Homestake Mining Company of California

July 10, 2026

**RE: Responses to the Request for Additional Information on the Discharge Permit
Renewal, DP-200, Homestake Mining Company, Grants Reclamation Project**

NOTE: SEE FIGURE 5 FOR LEGEND
WITH WELL DESIGNATIONS

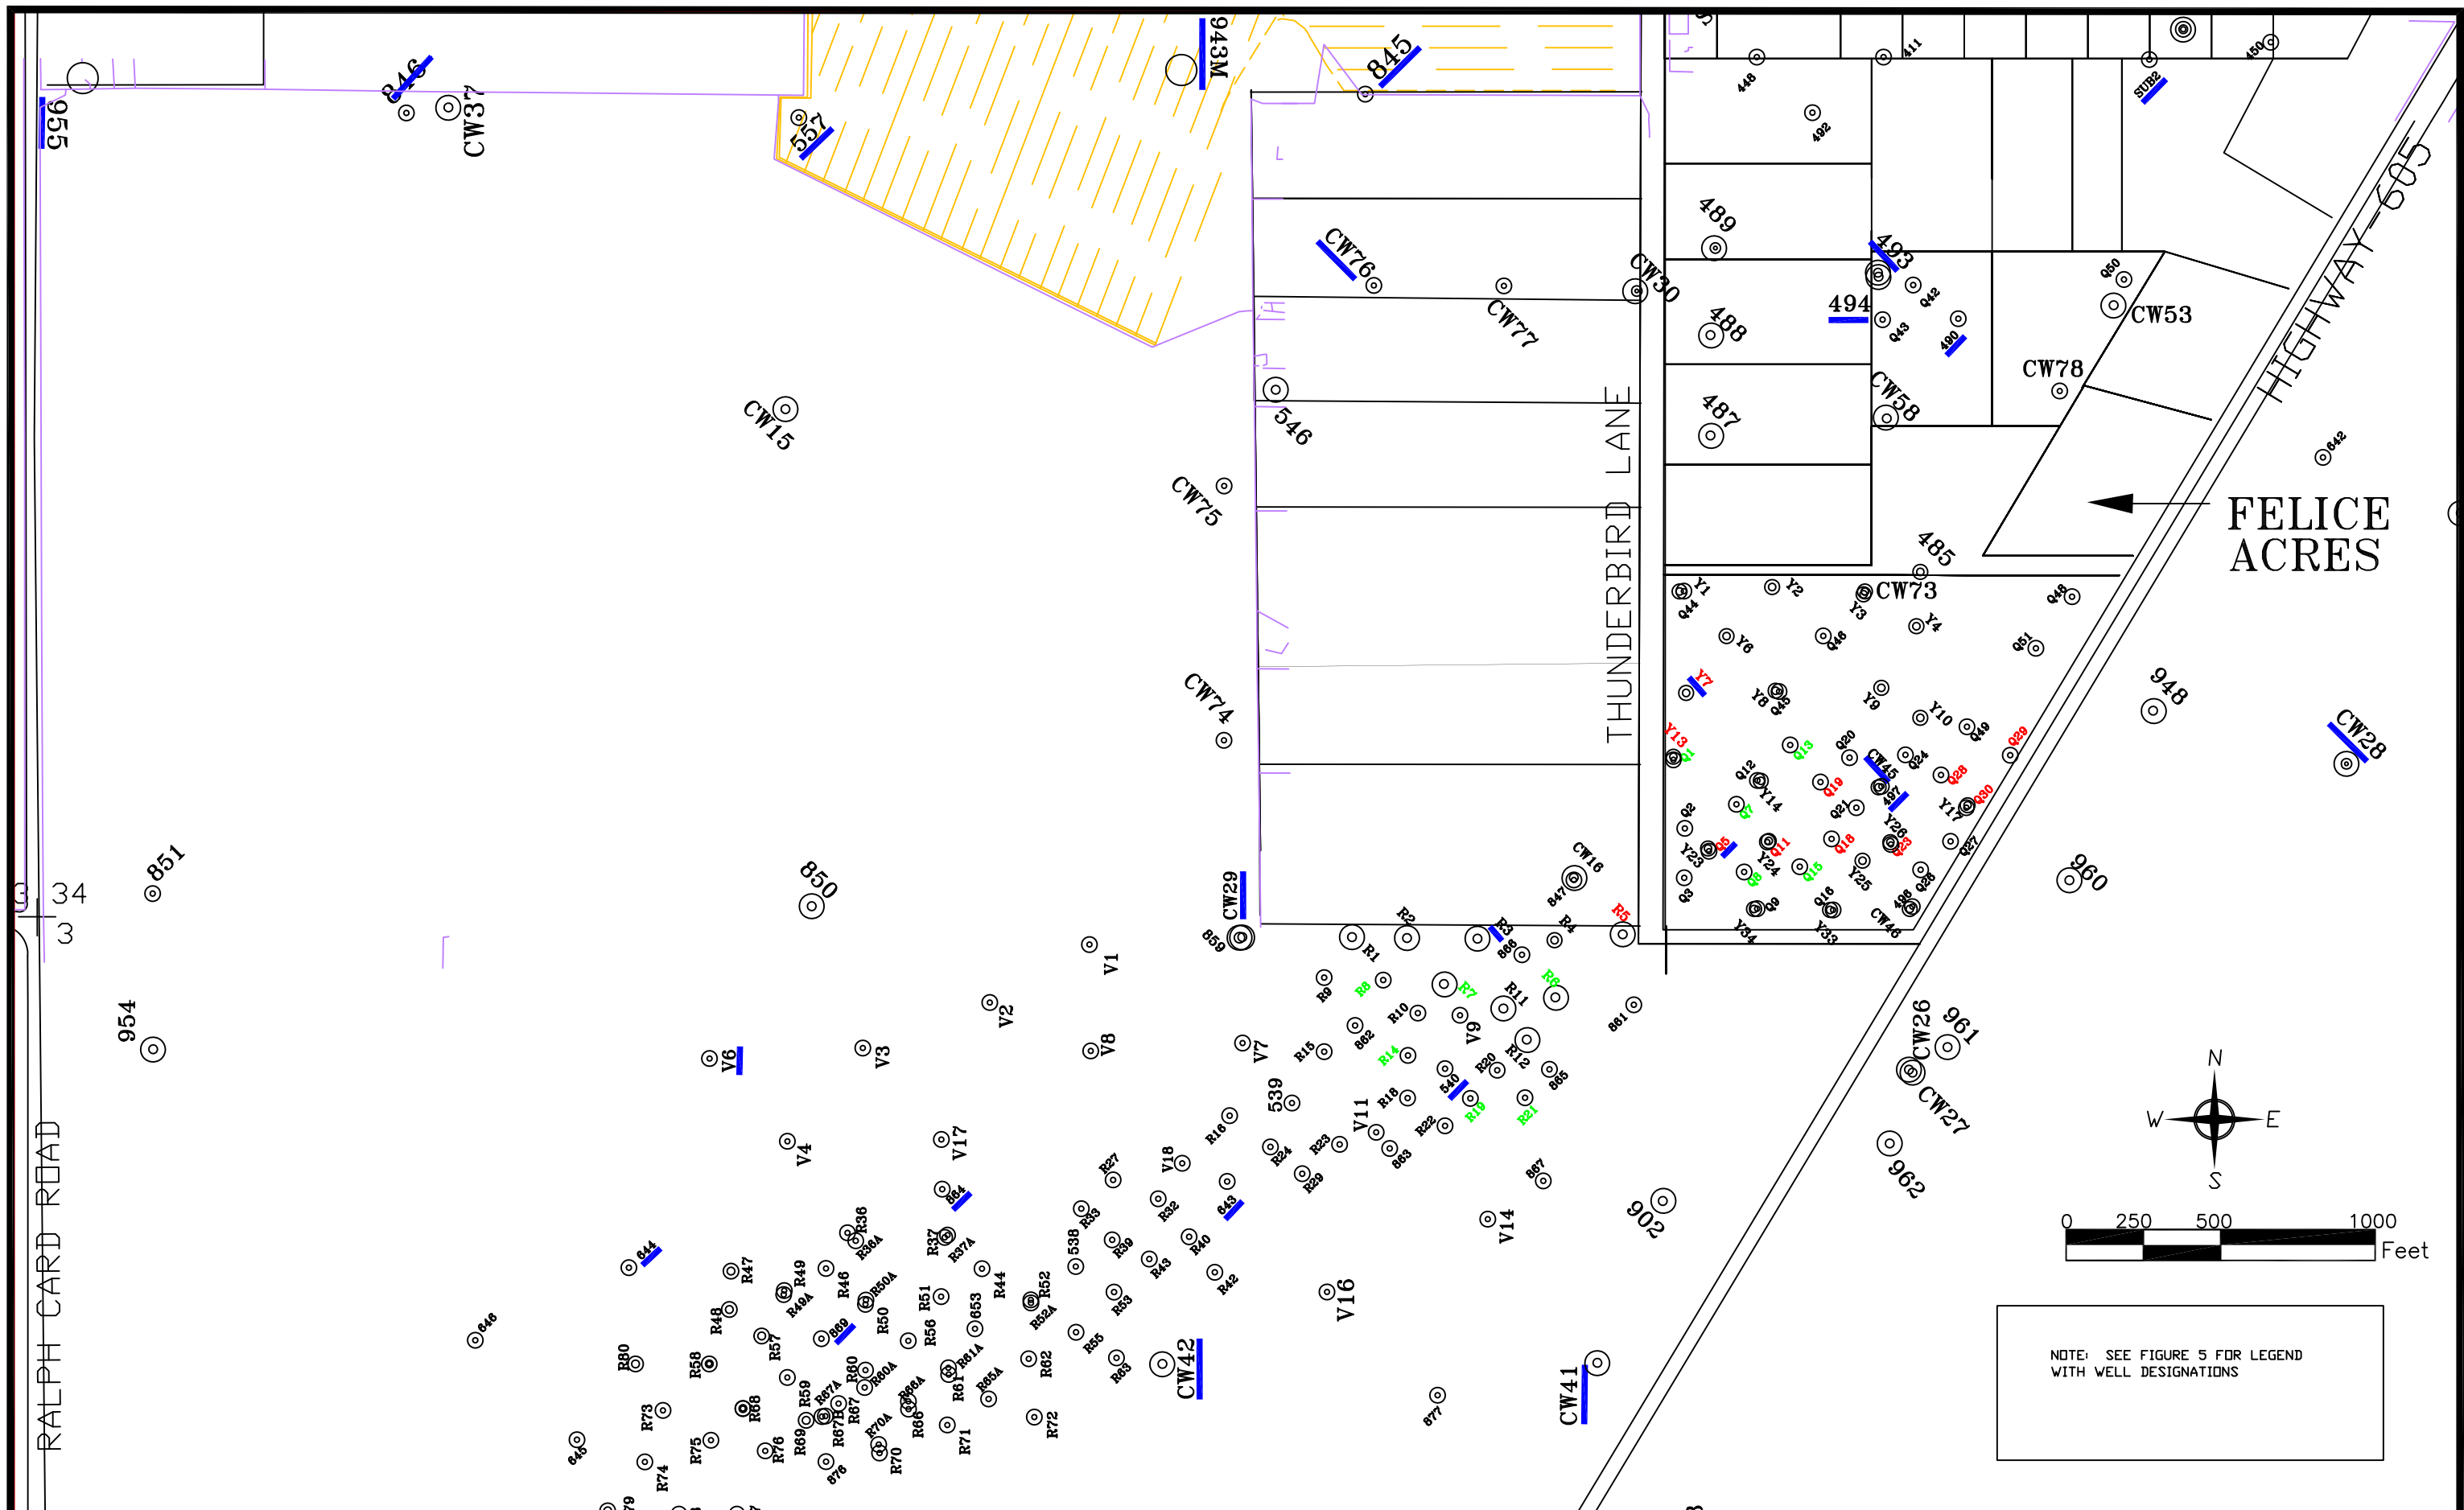
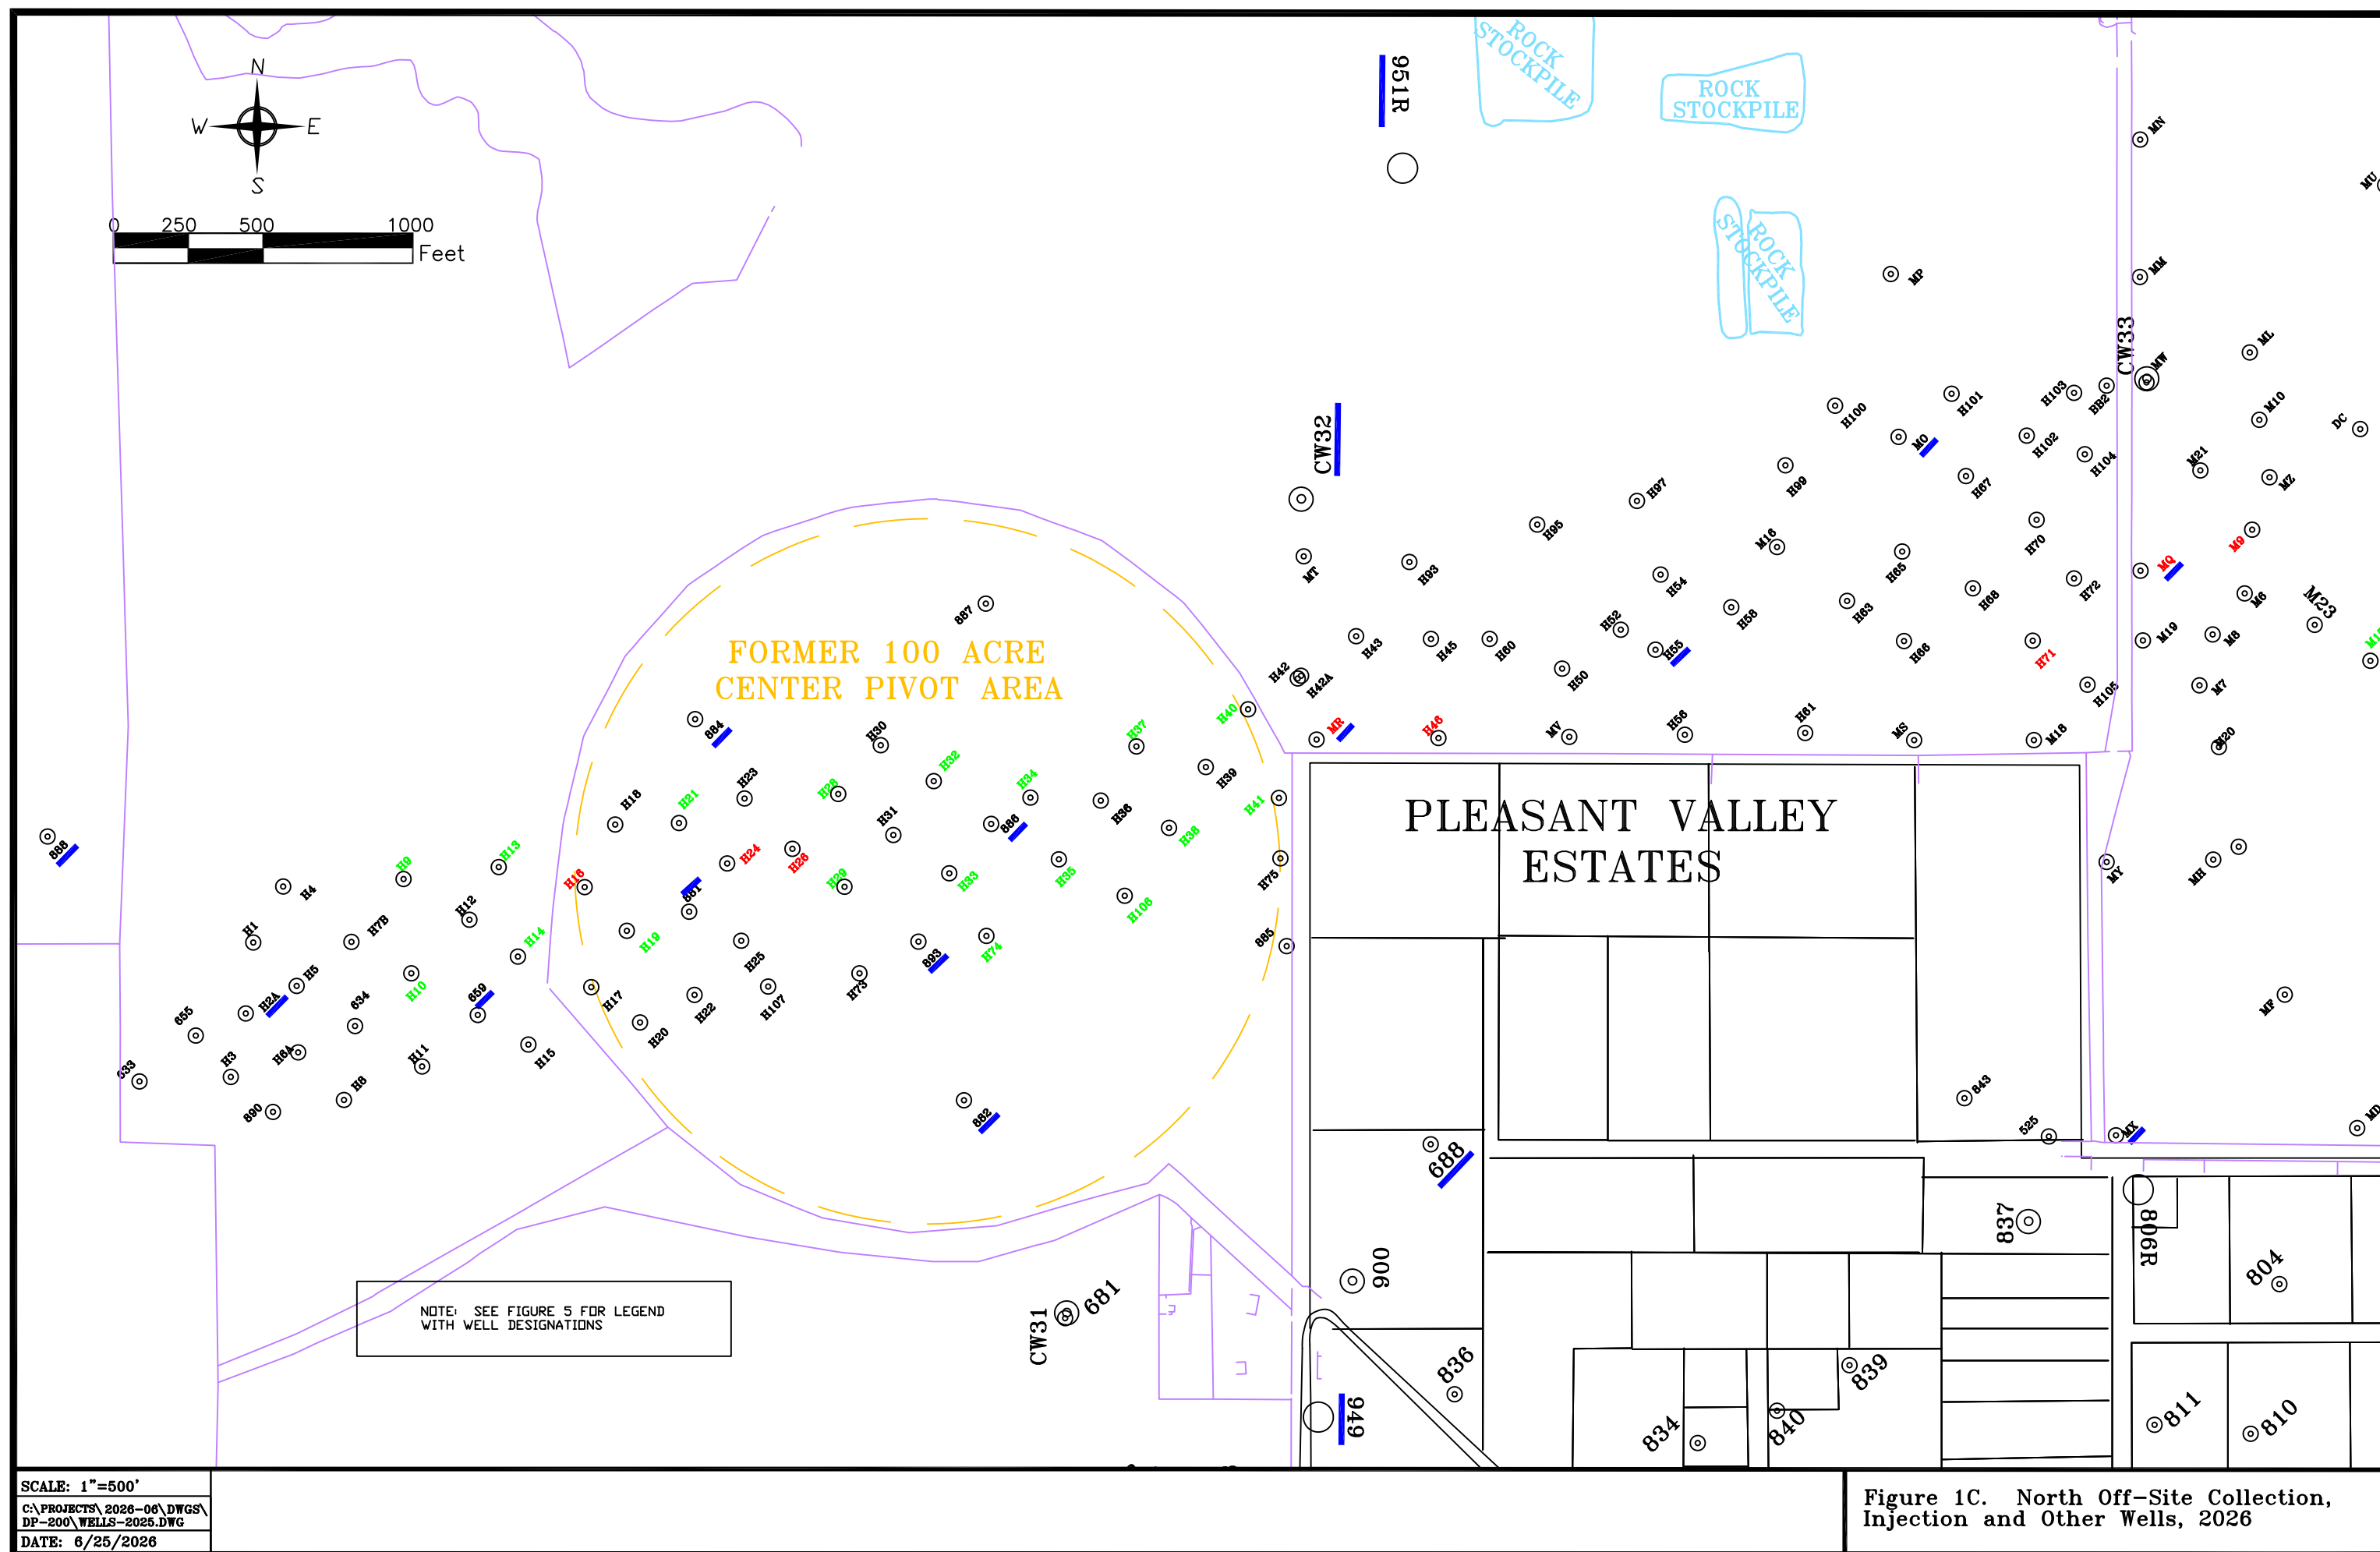
8. Part II Technical Completeness, 2a. Please provide updated maps, to replace and update those initially included in the 2019 discharge permit renewal application.

15. Part III Additional Proposals and Conditions. Please provide an updated underground injection control (UIC) listing of wells as required by Discharge Plan Condition 48 (DP-200 amendment 14-01 dated December 30, 2014). The recent Quarterly UIC Reports list wells that do not match what is shown in the Annual Monitoring Reports / Performance Reviews. For example, the 3rd Quarter 2024 UIC Report dated October 31, 2024, lists wells that do not match what is shown in Figures 4.1-1, 4.1-1A, 4.1-1B, and 4.1-1C in the 2024 Annual Monitoring Report / Performance Review. Specifically, well 496 is listed as active but not listed as an injection well in Figure 4.1-1B. Well 655 is listed as active but not listed as an injection well in Figure 4.1-1C. Infiltration line RCR7 is listed as active but not listed as an active infiltration line in Figure 4.1-1B. Please provide a map identifying the UIC-listed wells, along with an operational plan describing the planned use of each UIC well.

- **Attachment E** contains Figures 1, 1A, 1B and 1C which are an update to Figure 1 in the 2019 Application and show the current location of collection and injection wells at the Grants Site.

Part III does not expressly require information related to UIC wells. However, please find included herein **Attachment E**. This Attachment lists the UIC wells and depicts the location of all UIC-listed wells.

Attachment E presents the location of wells for the Grants Site with green labels indicating potentially active injection wells or recharge lines. The injection capacity of the injection sites shown as potentially active exceeds the supply of R.O. product water, and only a portion of the injection sites will be used at any given time. A priority for operation has been assigned to groups of wells and recharge lines to distribute the injection water to areas where it will contribute to hydraulic containment and/or general groundwater restoration. The priority system has been developed by general area (On-Site, South Off-Site and North Off-Site) and by location within that area. Because there are a large number of injection wells and recharge lines available, a specific operational plan is not presented for each well or recharge line, and some of the available wells or recharge lines shown on the associated map figures may not be used. There may also be infrastructure and distribution system constraints that affect utilization of some injection sites, so the priority system is used to manage the injection program. Given these
